# Deep Life Open Revolution Family of Rebreathers Design Verification Report: Rebreather Power Architecure

DOCUMENT NUMBER: DV\_OR\_Power\_080319.doc

REVISION: A2

The scope of this document is a design verification of the Power Architecture in the Base\_Unit circuit revision C1 according to QP-20.

Figure 1: Base Unit Batteries Switches Block Diagram.

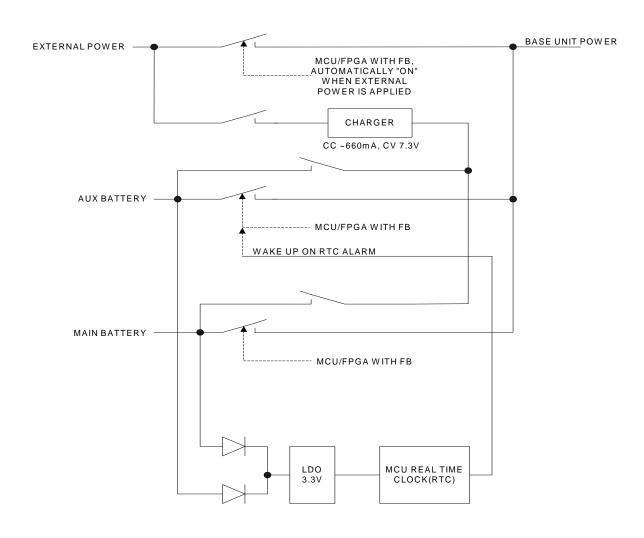
- 5. There is no means to limit current between batteries and MUX output. There is a diode in the MUX power supply protecting from the reverse current but whole MUX will be powered from batteries until switches are reconfigured. It may pull the whole rail very low in worst case causing power failure in FPGA and MCU.

- 6. There is a general concern that the MCU and the FPGA must act very fast to prevent the loss of power, when umbilical power drops out. A diode scheme is preferred by the reviewers, but after consideration of the fail-safe backstop using the RTC, accept that the scheme is suitable for a safety system.

- Replace power switching FETs with diodes to avoid need to have MCU or FPGA
- 2. Change MUX wiring and Base unit wiring, so Vbus pin connecting the two, uses only one pin: on the left side. The right hand side becomes the PFD data pin, which is respect to ground. Base unit is the only connection to the PFD, connecting to MCU only: the PFD is a monitor. The Base unit has to relay Diver Alert Switch and Helmet Open Switch data back to the MUX: it becomes part of the Base unit status frame.

- 5. Allow the Base to power the PFD from its battery power. To do this, put FET and op-amp in parallel with a protective diode in the Base to provide a source limited to 250mA from the Base Unit to the MUX power pin, so the MUX can maintain the PFD only. Add an extra diode to the MUX just in front of the connection to the Base that stops the Base from powering the MUX. Add a linear regulator to the PFD to reduce the voltage from the Base Unit to 3V3.

**Figure 2:** State-Transition diagram for rebreather power sources. State S x,y where x denotes whether there is umbilical power (0, or 1 as a binary parameter), y denotes whether there is battery power, also as a binary parameter.

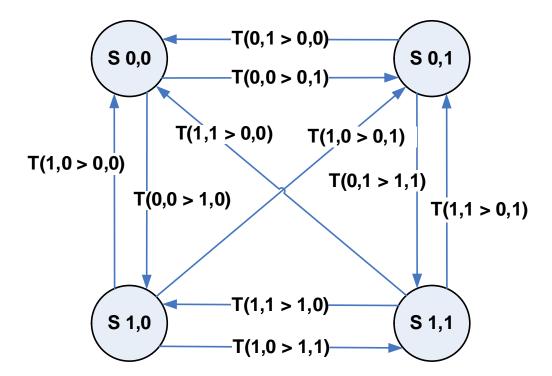
- **State(0,0)** is where the umbilical power is off, and battery power is off. This steady state is safe, in that it does not damage the electronics.
- State(1,0) is where the umbilical power is on and battery power is off. This steady state has been used extensively in lab tests, and has been reviewed. It appears to function correctly.
- State(0,1) is where the umbilical power is off and battery power is on. This steady state has been tested less extensively, but has been tested: it was demonstrated at DEMA and was used in the unit in St Petersburg for the trials to 5<sup>th</sup> March 2008. It appears to work.
- State(1,1) is where the umbilical power is on and battery power is on. <u>This is a fault condition: the MCU and the FPGA must follow the correct protocol, otherwise this fault condition will occur.</u>

The FPGA and MCU must prevent the equipment ever being in State(1,1), but it would be prudent to check the equipment is not damaged should the power supplies enter this state transiently due to capacitance etc. The way the equipment avoids this state is that when the umbilical power is applied after the unit has been running from batteries, the batteries umbilical. detected will trv drive the This is "ON\_HANDSET\_BATTERY\_FB\_MCU" and "ON\_HANDSET\_BATTERY\_FB\_FPGA" on page 3 of the circuit diagrams: the names are a little misleading, as they date from the use of the handset to power the rebreather - the Top Side Unit and Umbilical Terminator are a substitute for the diver's handset.

Figure 3: State-Transition diagram showing transitory state S(0,0+) and its links. All invalid transitions are excluded from this diagram, e.g. S(1,0) to S(1,1).

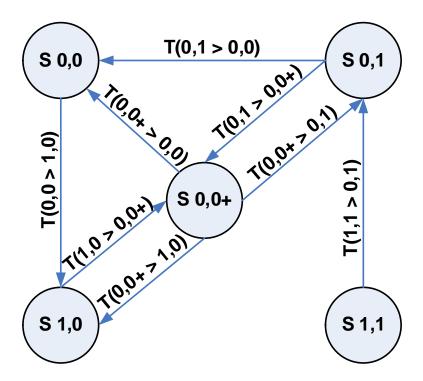
Transition from S(1,0) always goes to this state first and then from this state into S(0,1) when comparator detects low voltage in POWER\_SUPPLIES node.

There is no direct path from S(1,0) to S(0,1) or visa versa, but transitions could exist theoretically.

The Base Unit does go from S(0,1) to S(0,0+) periodically, otherwise it cannot sense the presence of the main power source. If it is present then it goes from S(0,0+) to S(1,0) when the diode in the Umbilical Terminator starts passing current when capacitors at the POWER\_SUPPLIES node are discharged to 5.8V or so. If external power is absent it then goes back to S(0,1) for a while and then back to S(0,0+). If batteries are discharged it goes from S(0,0+) to S(0,0) and turns off completely. As the Umbilical Terminator X source has a diode to prevent from sinking current, State (1,1) seems unreachable when batteries have a higher voltage than the Umbilical Terminator source. A state diagram in the attached file below original diagram.

When batteries are discharging it shall not leave state S(0,1) if the comparator sees the POWER\_SUPPLIES node below the threshold to switch to a battery. Thus when batteries are discharging it goes to S(0,0) from S(0,1) directly, not through S(0,0+)

When the unit is turned off normally it shall go to S(0,0) from S(0,0+).
